AMENDMENT NO. 3 TO FACILITY OPERATING LICENSE NO. DPR-51

CHANGE NO. 3 TO TECHNICAL SPECIFICATIONS

ARKANSAS NUCLEAR ONE, UNIT 1

DOCKET NO. 50-313

FIG. NO.
4-5

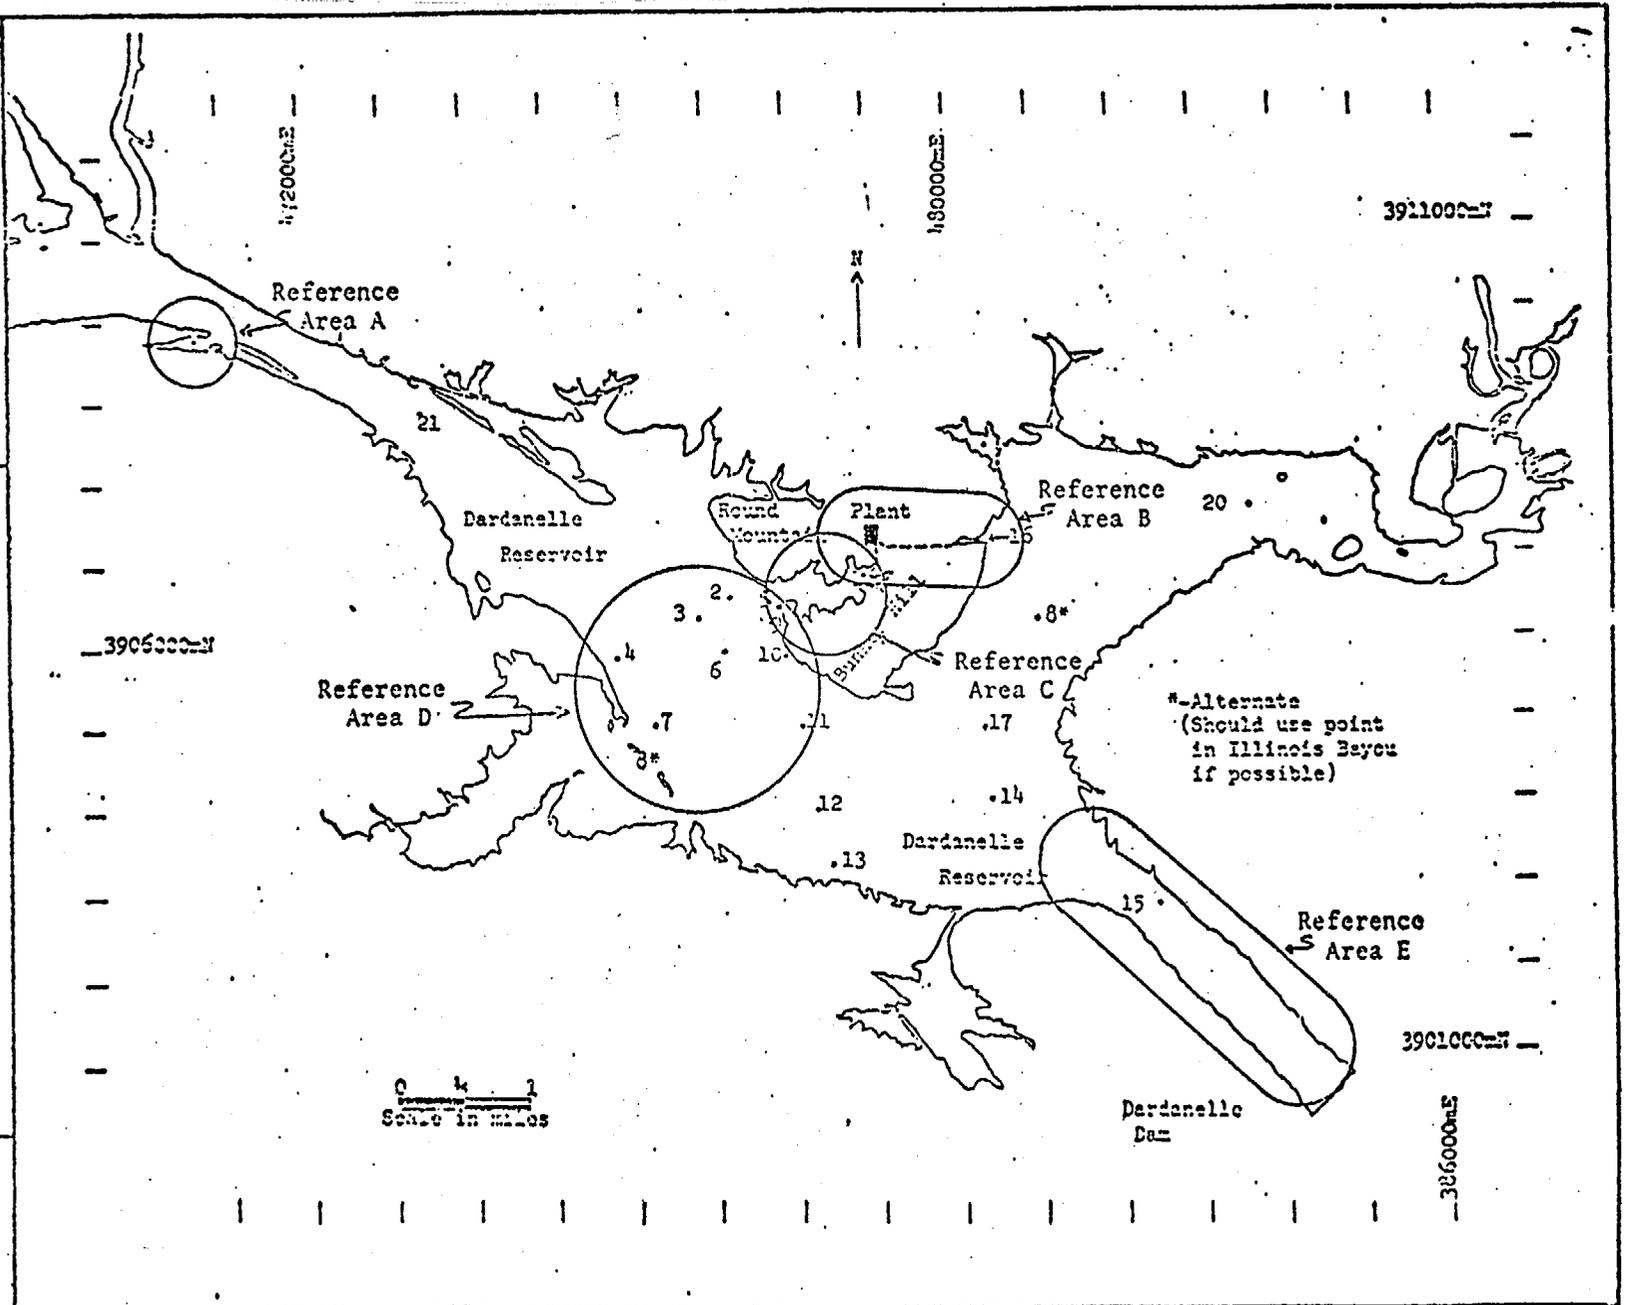
- (1) Specification 4.1.2.a.(1).(a).3),a), for gill net survey redistributes but does not change the total number of sampling days.
- (2) Table 4-3 and Figure 4.3 are revised to correctly identify sample location 19 and identify sample areas. Establishment of sample areas rather than specific locations for Cove Rotenone Trawling and Shoreline Seine and Fish Cage Surveys.
